Water Resources Report
For
Solace Apartments
El Paso County, CO

January, 2020

JR Project No. 25174.00

POWERS BLVD. COLORADO SPRINGS CONCEPTUAL SITE PLAN PHASED OPT 3

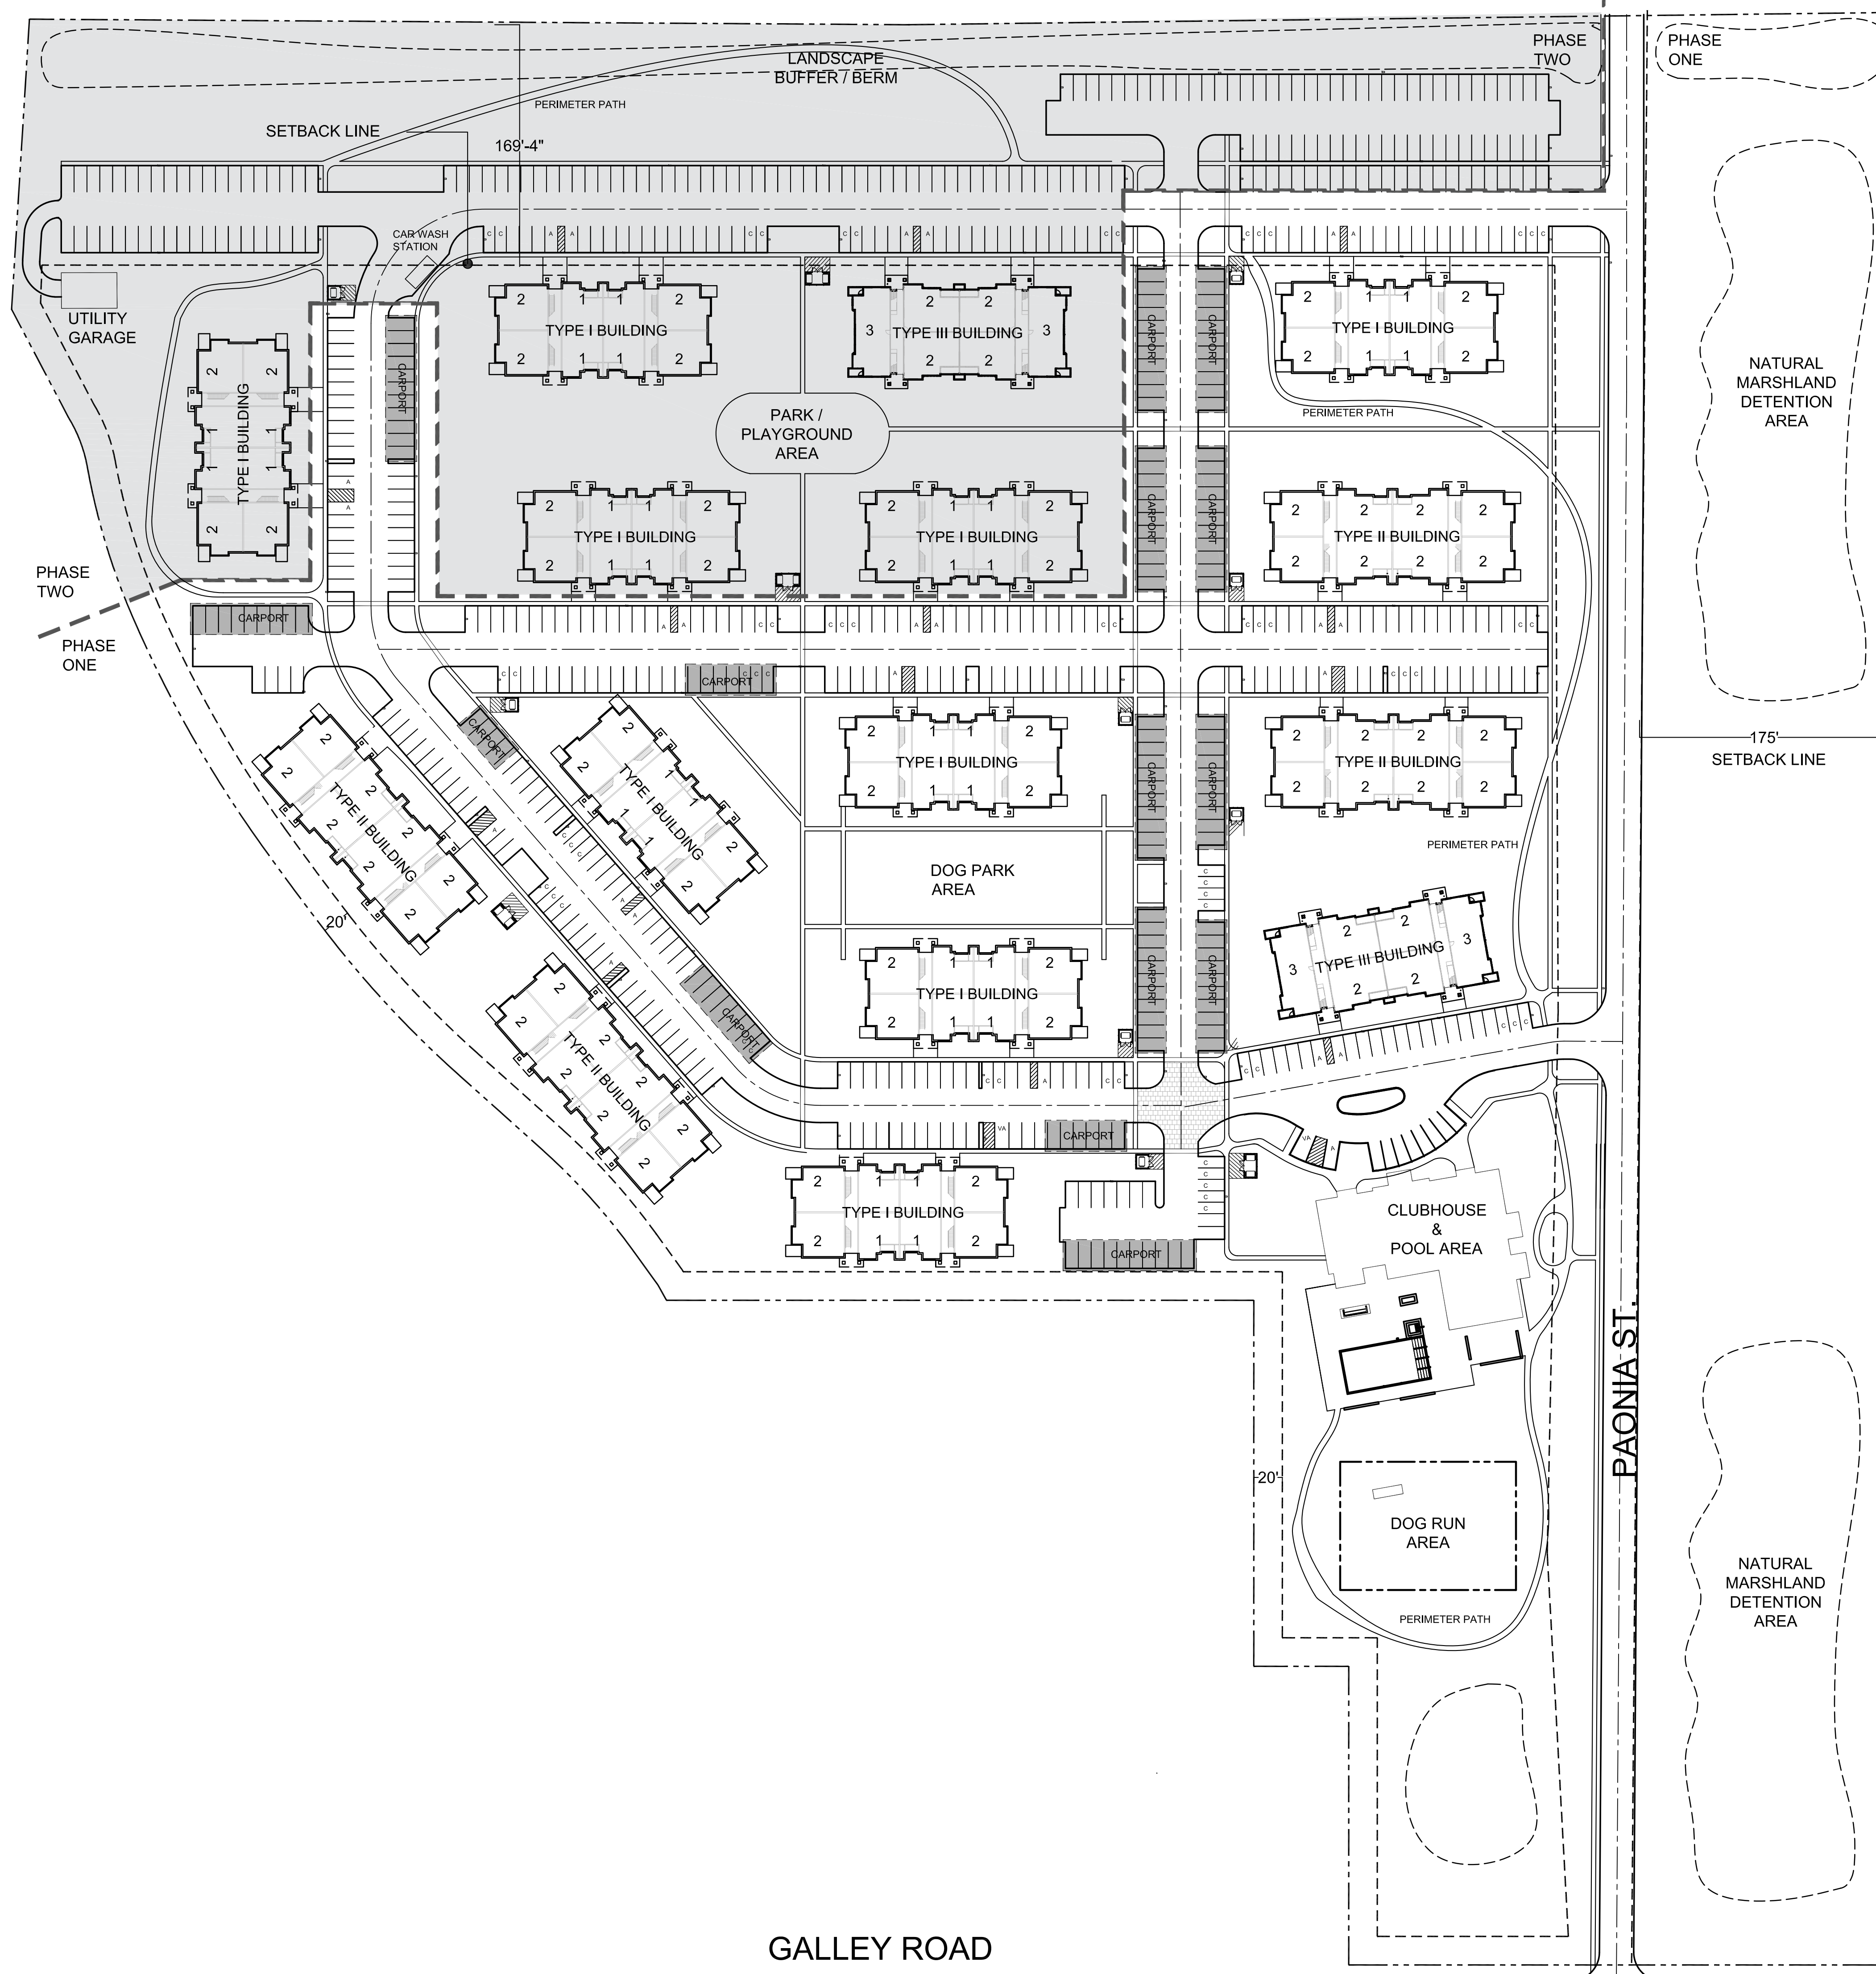
If proceeding with 2 phases and 2 lots this does not need to change, if proposing 1 lot then it will need to be updated
